**THE REGIONAL MUNICIPALITY OF YORK**

**Request for Tender No. T-19-349 Addendum #1**

**For:** Interior Renovation – 3<sup>rd</sup> Floor Block A, B, & D at the York Region Administrative Centre

ADDENDUM

**E-3.6**

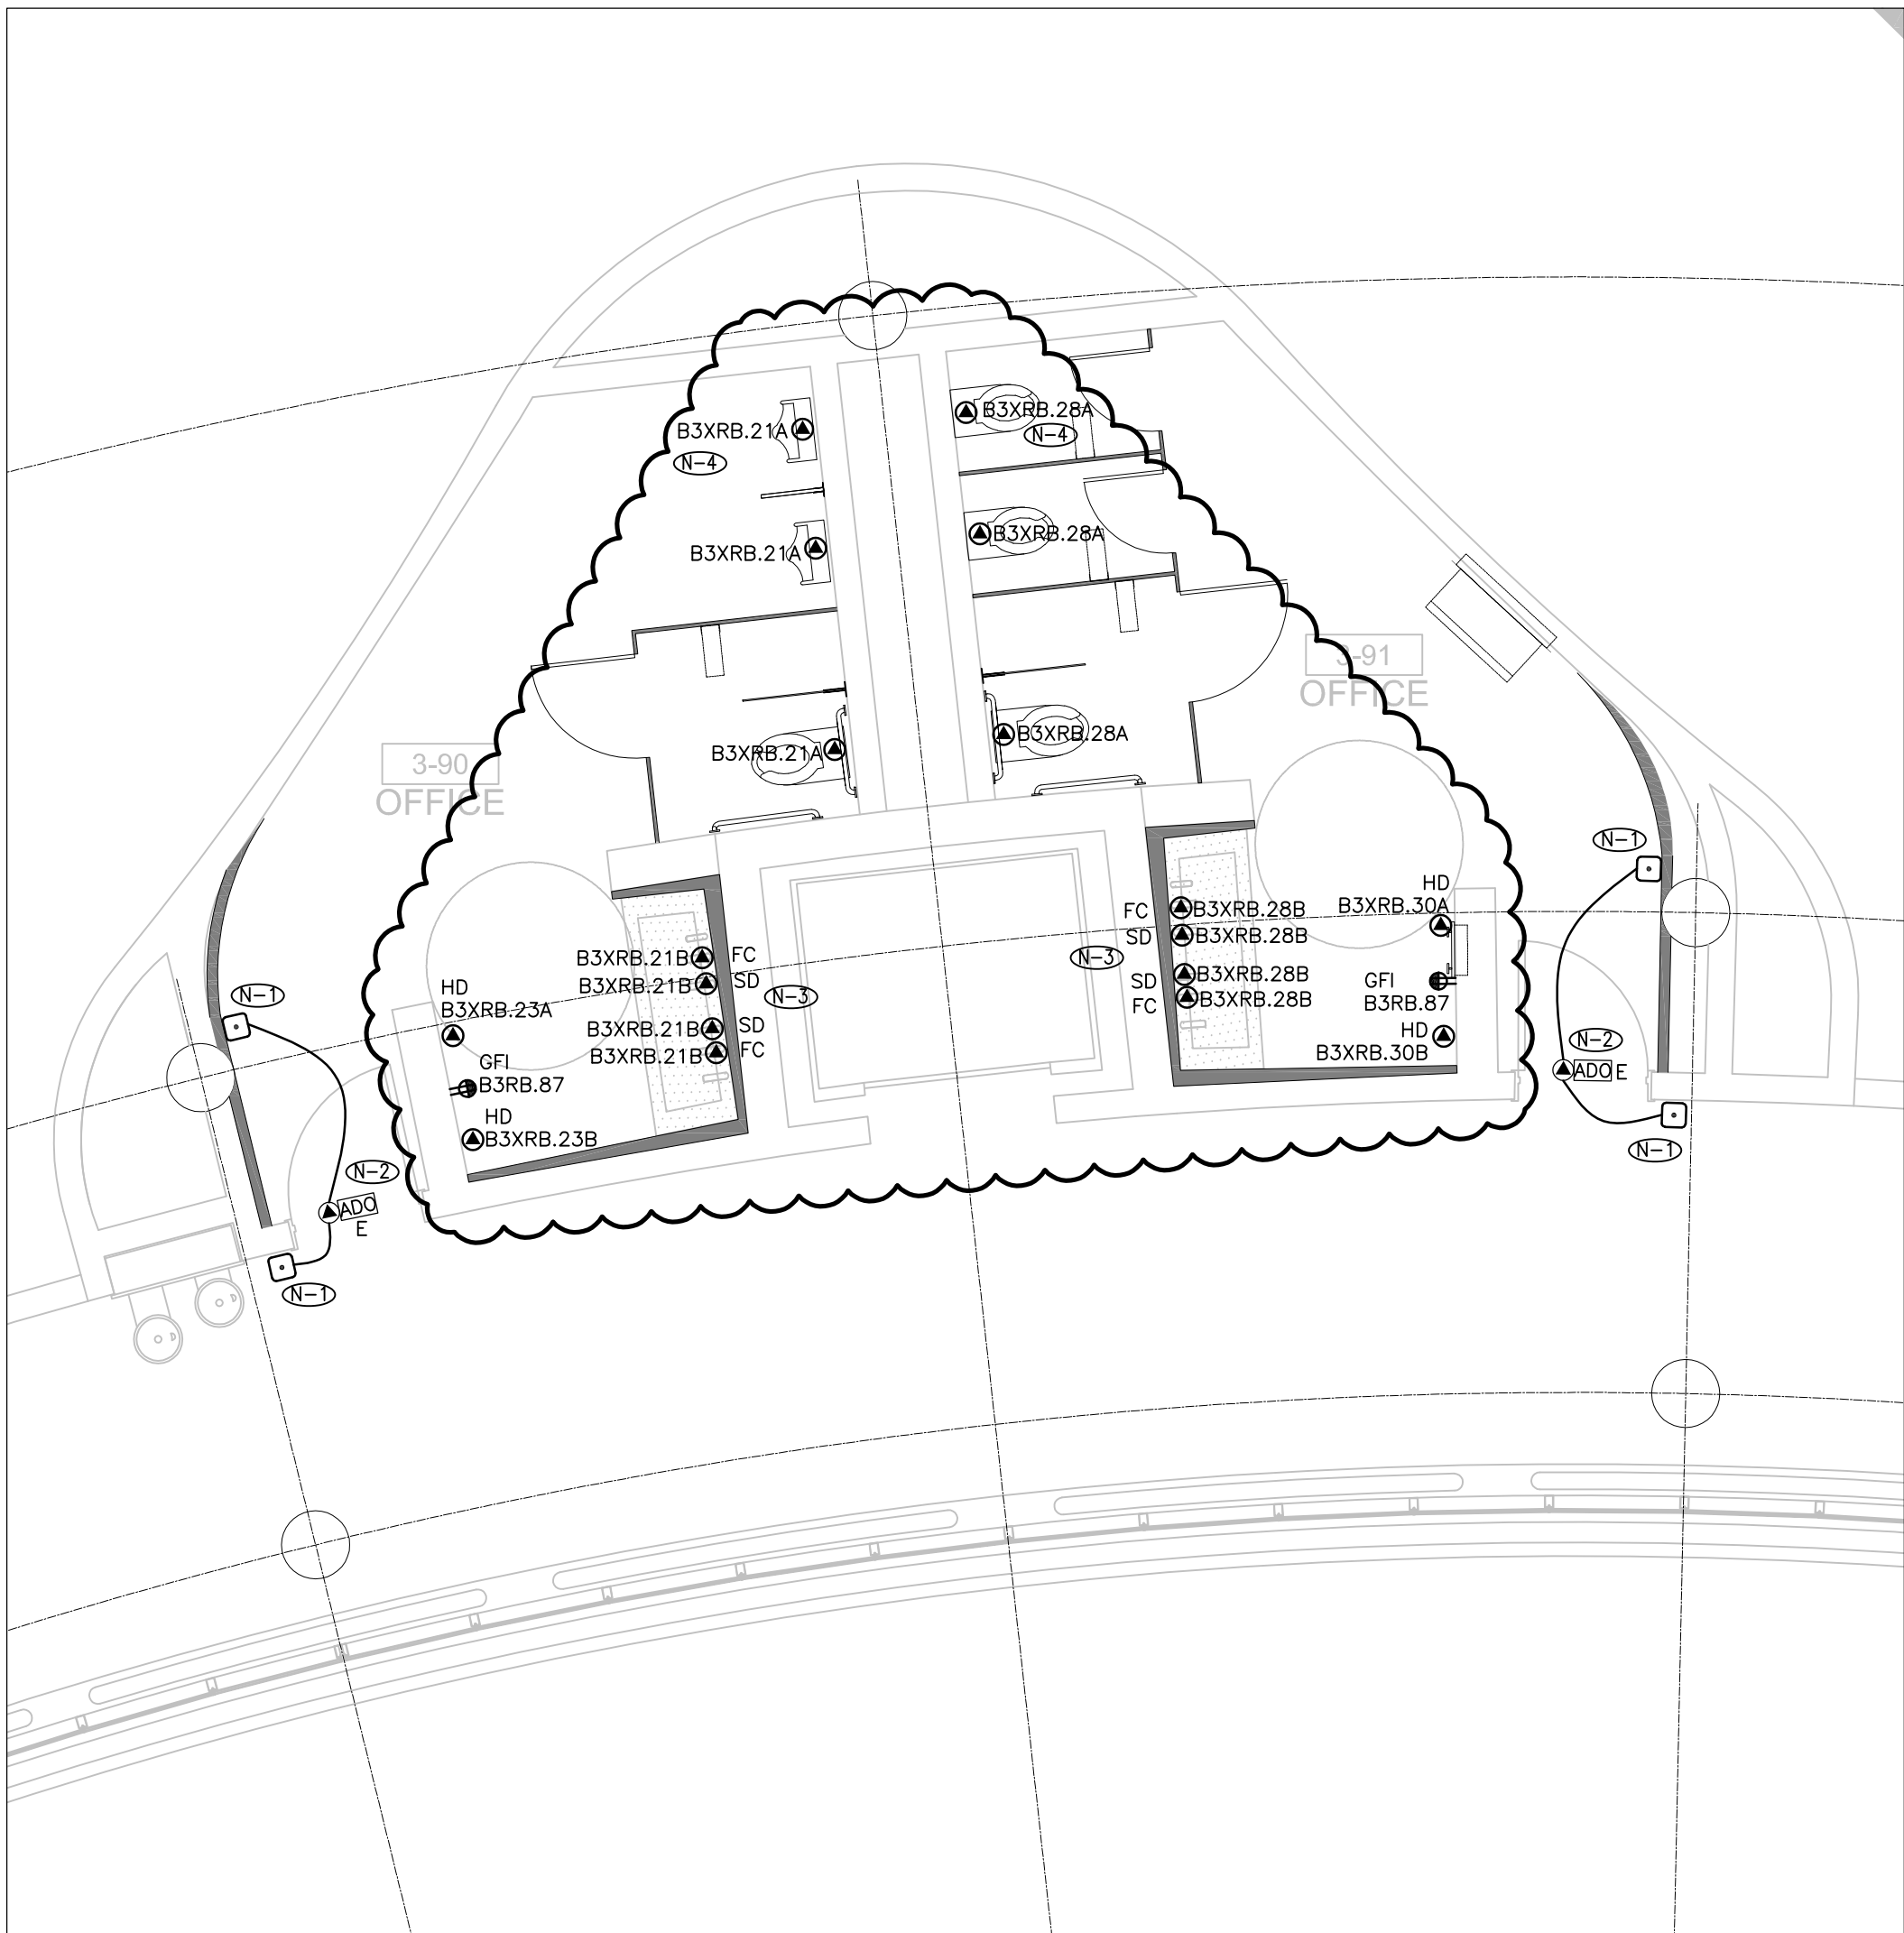
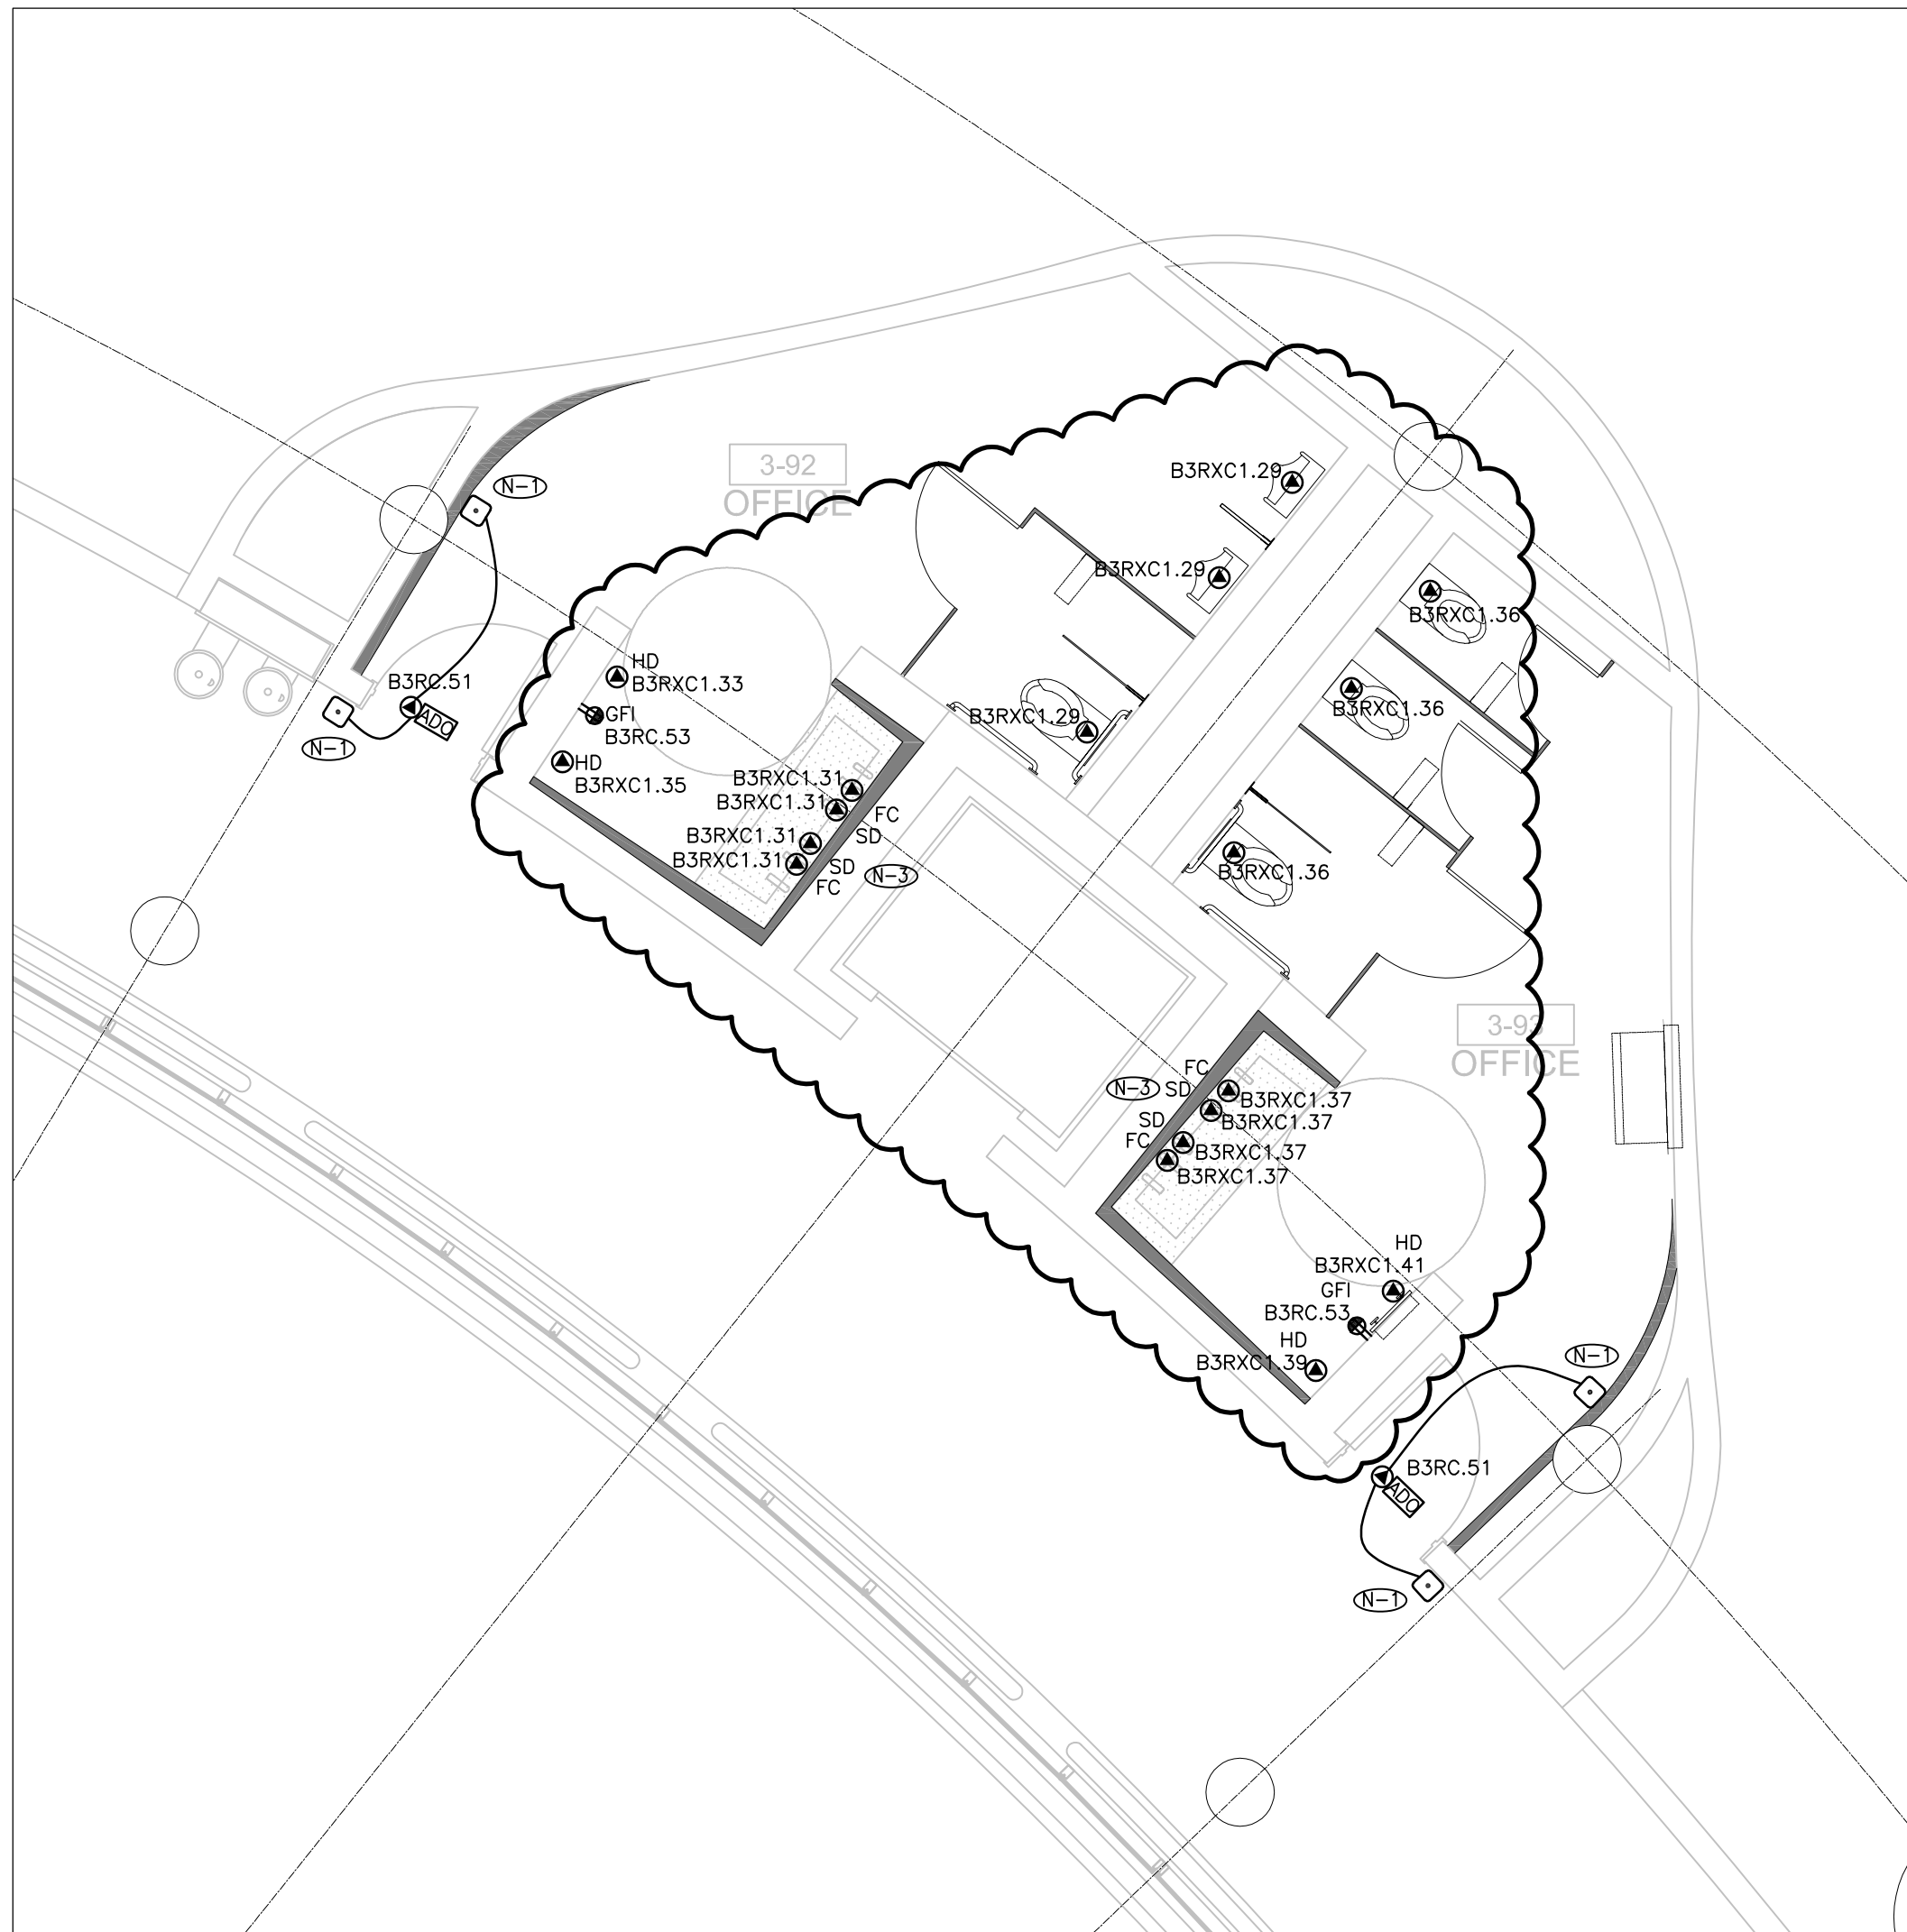
#### 1.1 Refer to E-3.6 – LEVEL 3 WASHROOMS – POWER AND SYSTEMS LAYOUT (included herein)

1.1.1 Revise location and revise connection for hand dryers to be direct connects in washrooms, as shown.

1.1.2 Revise circuiting of washroom fixtures, as shown.

1.1.3 Add note N-4, as shown.

.1 “PROVIDE TANDEM BREAKERS FOR CIRCUITS SHOWN AS A/B. (TYP.)”
